Agenda
for
118th PCC Meeting

AGENDA FOR 118th PROTECTION COORDINATION SUB-COMMITTEE MEETING TO BE HELD ON 20.09.2022 AT 10:30 HOURS

Report on the grid event in Eastern Region (पूर्वी क्षेत्र में ग्रिड घटना पर रिपोर्ट)

Annexure 2: DR recorded

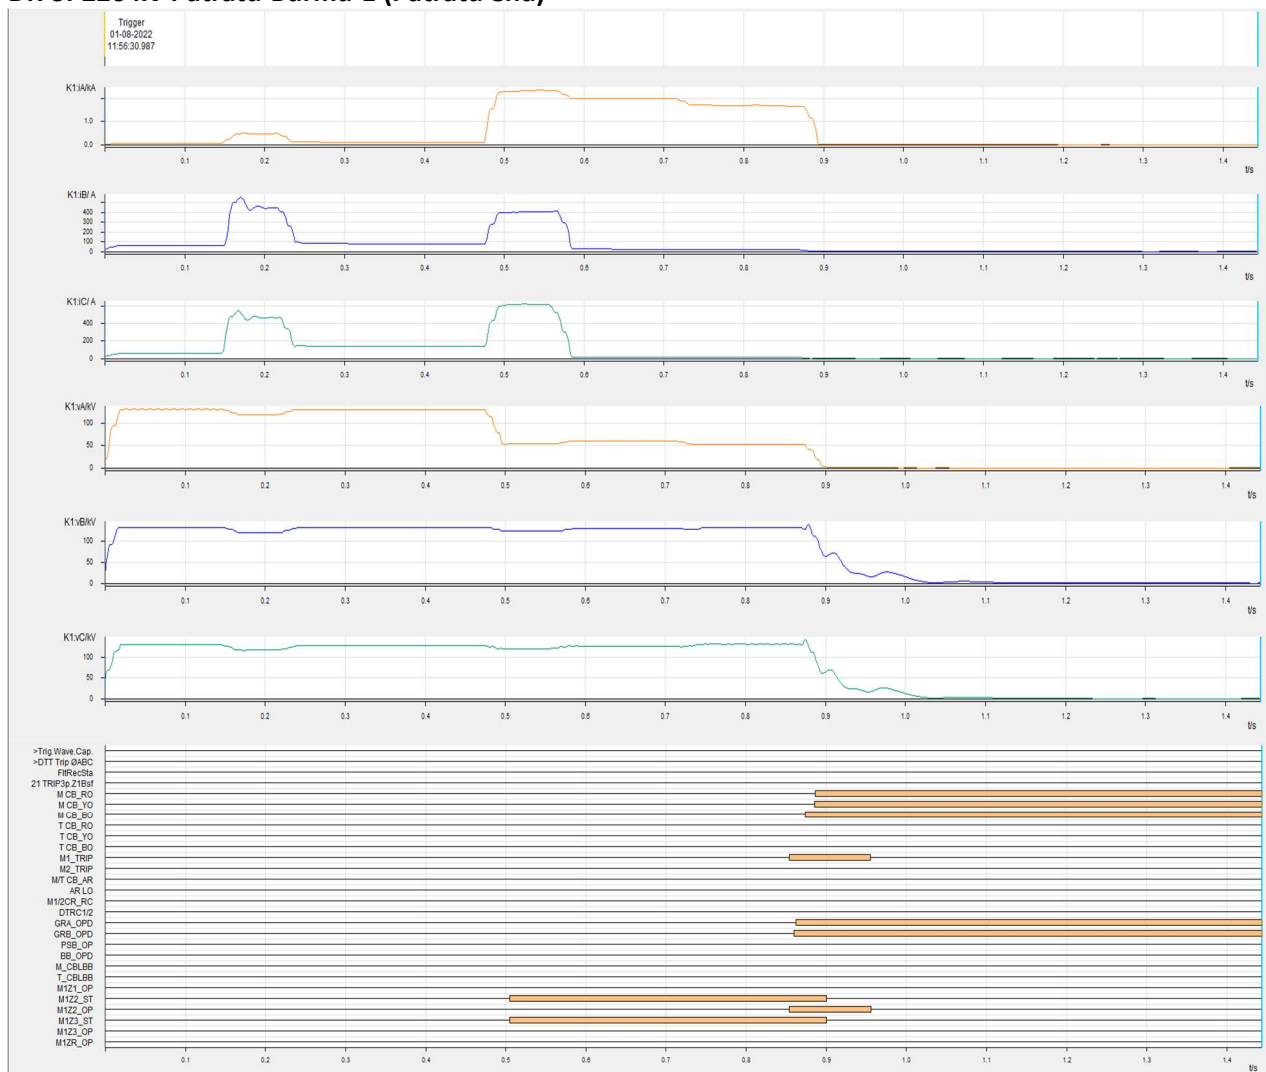
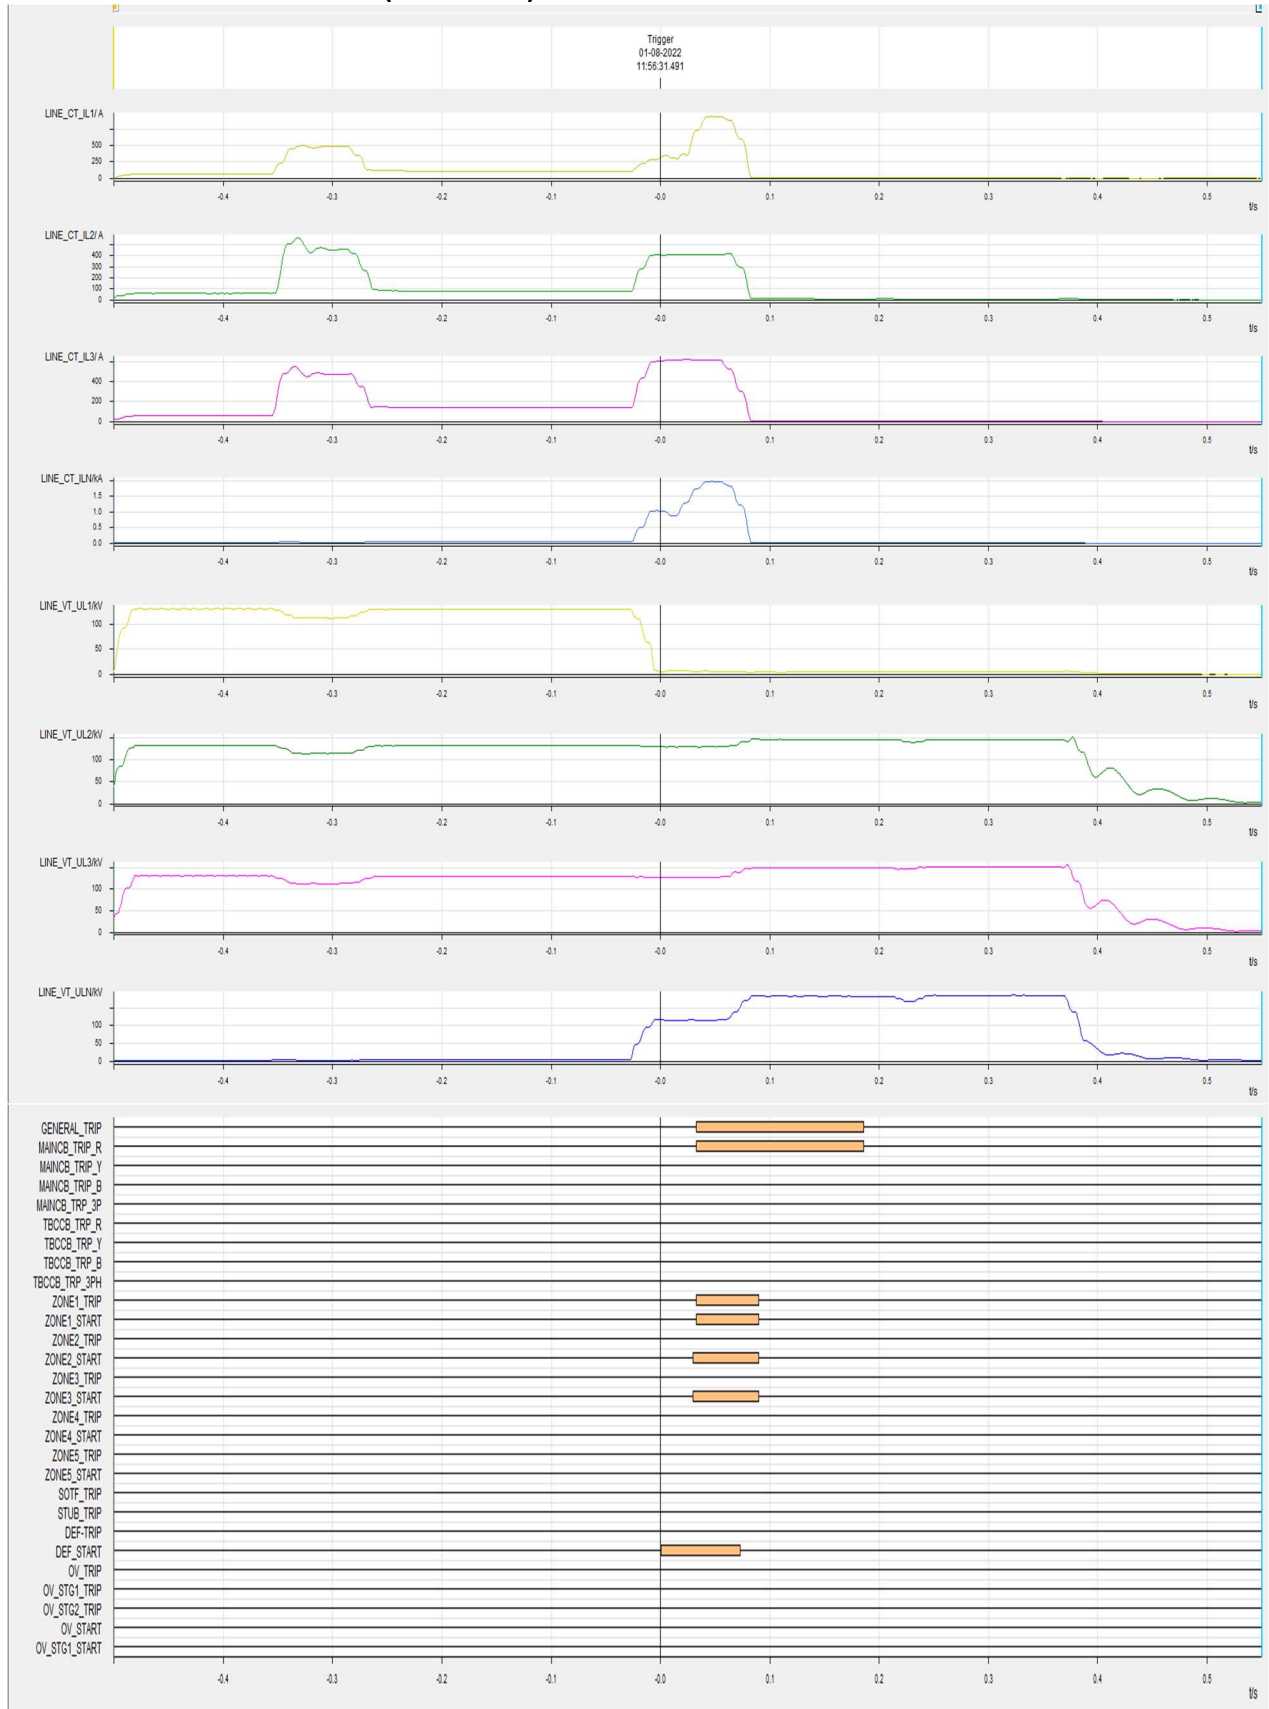
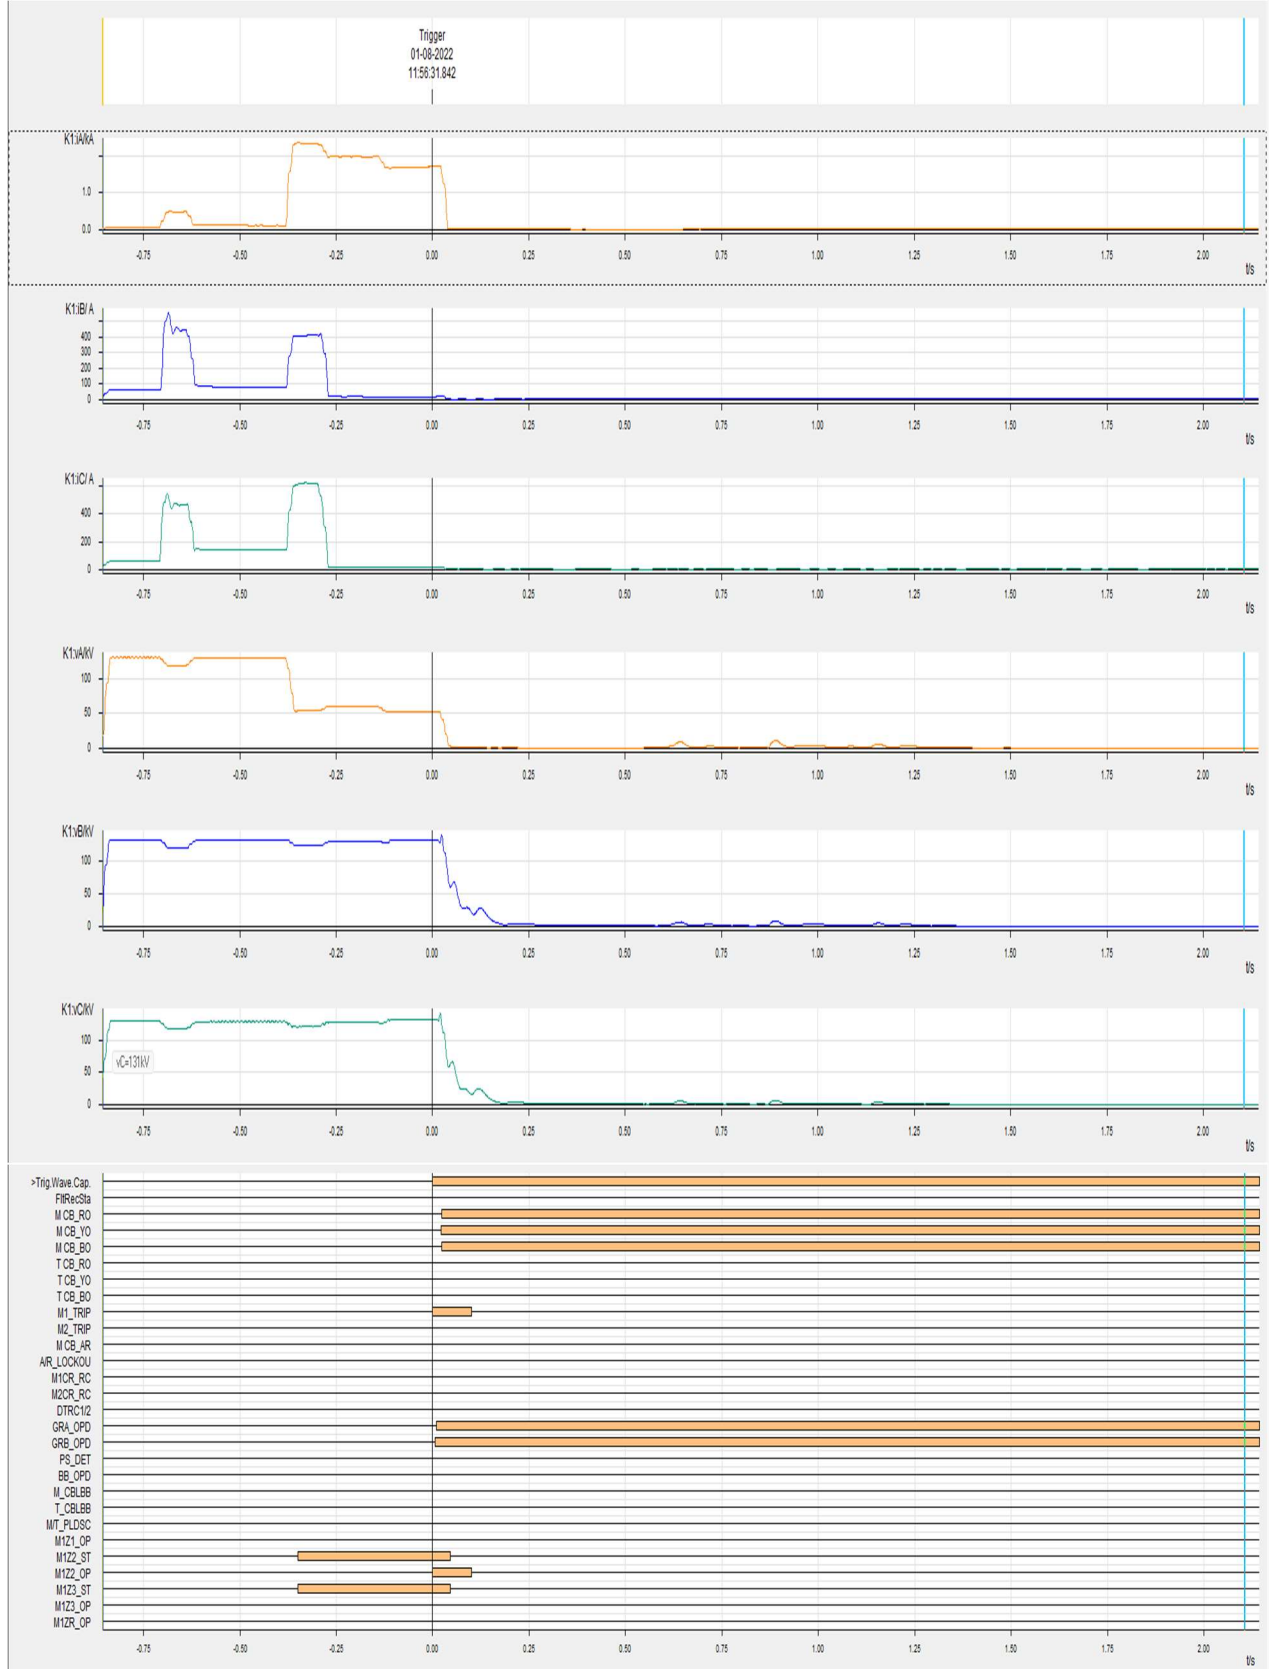
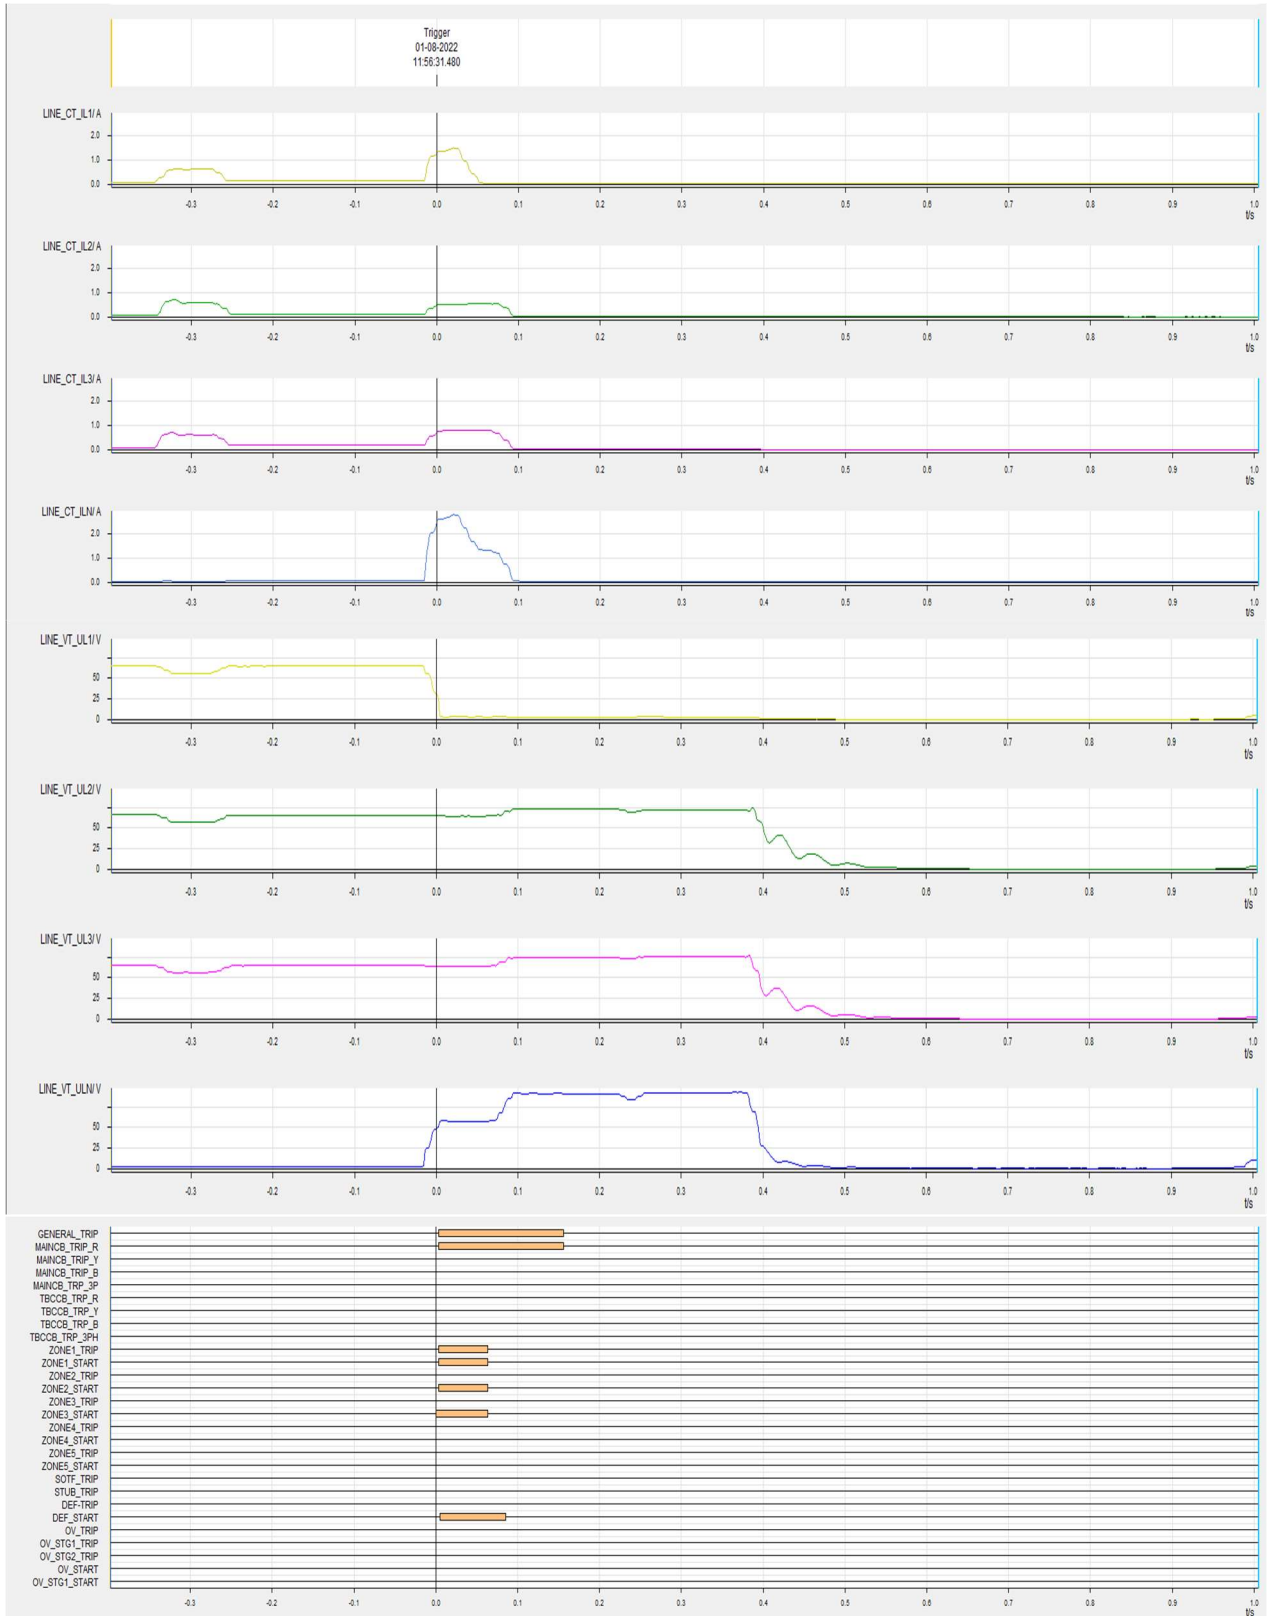
- R_ph fault struck both lines which was seen in Zone-2 from Patratu end and in Zone-1 from Burmu end.
- Both lines tripped from Burmu end within 100 msec. However, both lines opened in Zone-2 time from Patratu end. Whether carrier protection is healthy or not. JUSNL may confirm.
- At the same time, 400/220 kV ICT-1 at Patratu also tripped on Back-up O/c. Time co-ordination to be done to avoid tripping of ICT for faults at lower voltage level.
- DR triggering criteria for 220 kV Patratu-Burmu-2 at Patratu is set as **Any Trip**. The same may be changed to **Any Start**.

Figure 3: PMU Voltage snapshot of 400/220 kV Subhashgram S/s

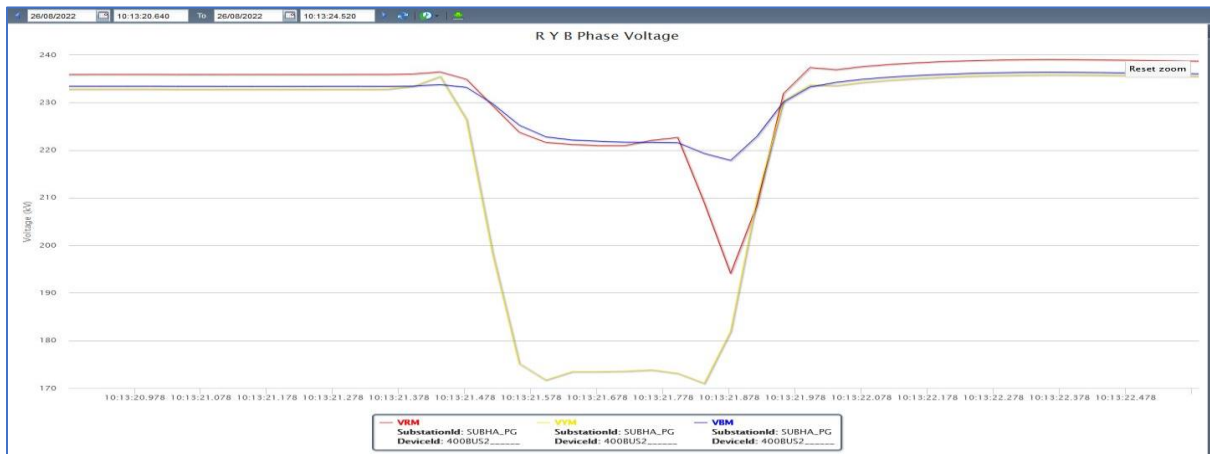
- Y_ph PT of 220 kV Bus-1 burst. Bantala has single main and transfer scheme.
- As informed, Bus bar protection was kept out of service due to failure of Y_ph unit of bus bar relay. Since when the Busbar was out of service, why Intimation of same was not given to ERLDC& ERPC.
- 220 kV Subhashgram-Bantala and 220 kV NewTown AA 3- Bantala tripped from remote ends in Zone-2 time after 350 msec.
- Z-4 timings of lines may be reduced till the Busbar is not in service.
- Expected timeline for restoration of Busbar may be intimated.
- ICT tripping occurred on which protection? **(WBSETCL to explain).**
